ISSUE: Permit to Demolish/Capsulate (partial) and Certificate of Appropriateness for alterations

LOCATION: Old and Historic Alexandria District
1250 South Washington Street, Unit 219

STAFF RECOMMENDATION

Staff recommends approval of the Permit to Demolish and Certificate of Appropriateness as submitted.

Figure 1: Location of Unit 219

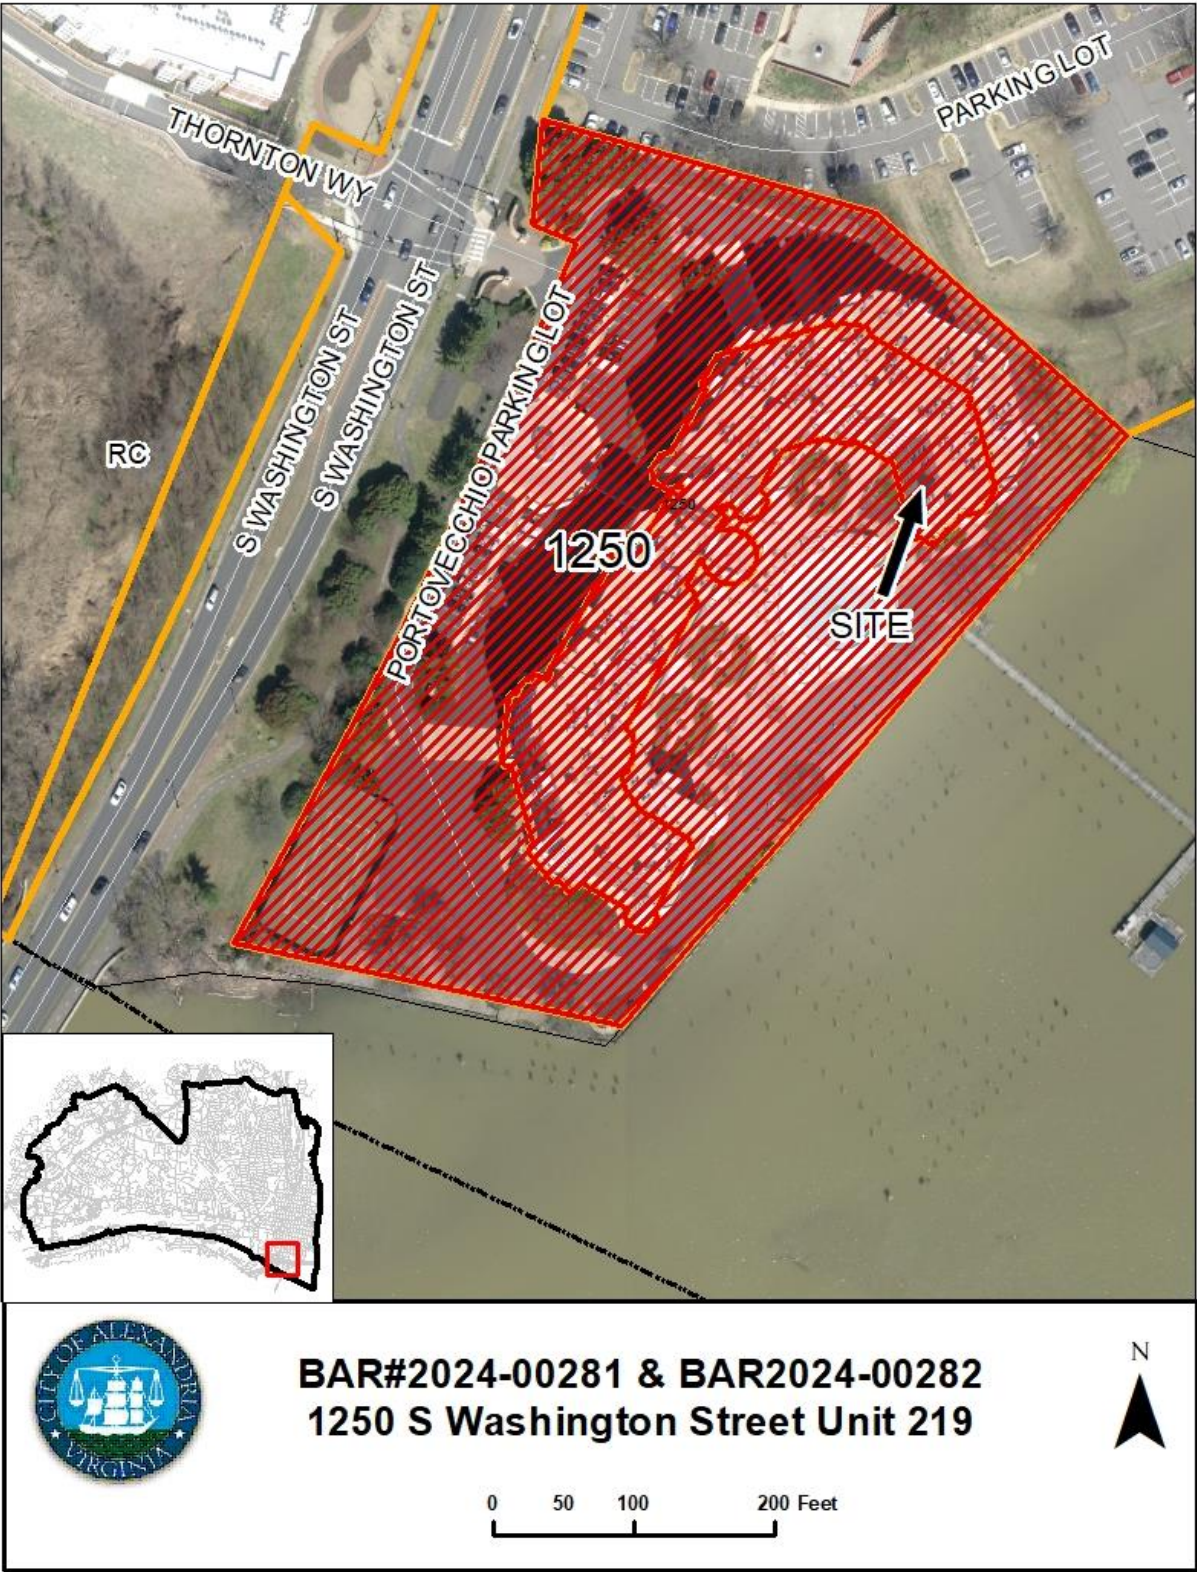
The condominium complex sits between the Potomac River and the George Washington Memorial Parkway. Unit 219 is on the river side of the building, facing south and overlooking the pool. It will therefore be minimally visible from any public right of way. See Figure 1.

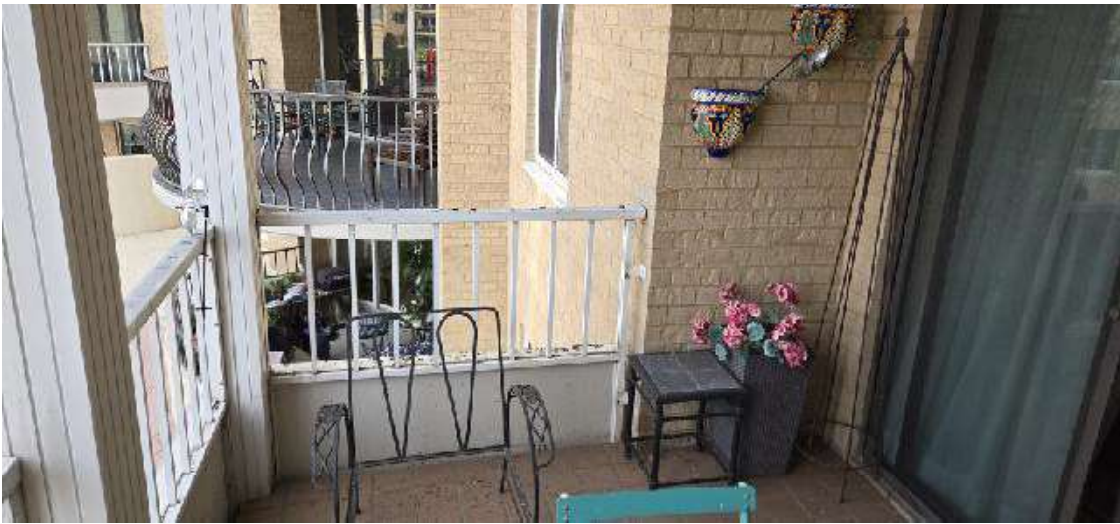
The question about the knee wall or solid panel at the base of the wall is a bronze 3" foam wall and probably won't be seen from the outside because of the existing handrail configuration. This will be bronze colored as the rest of the framing is bronze.
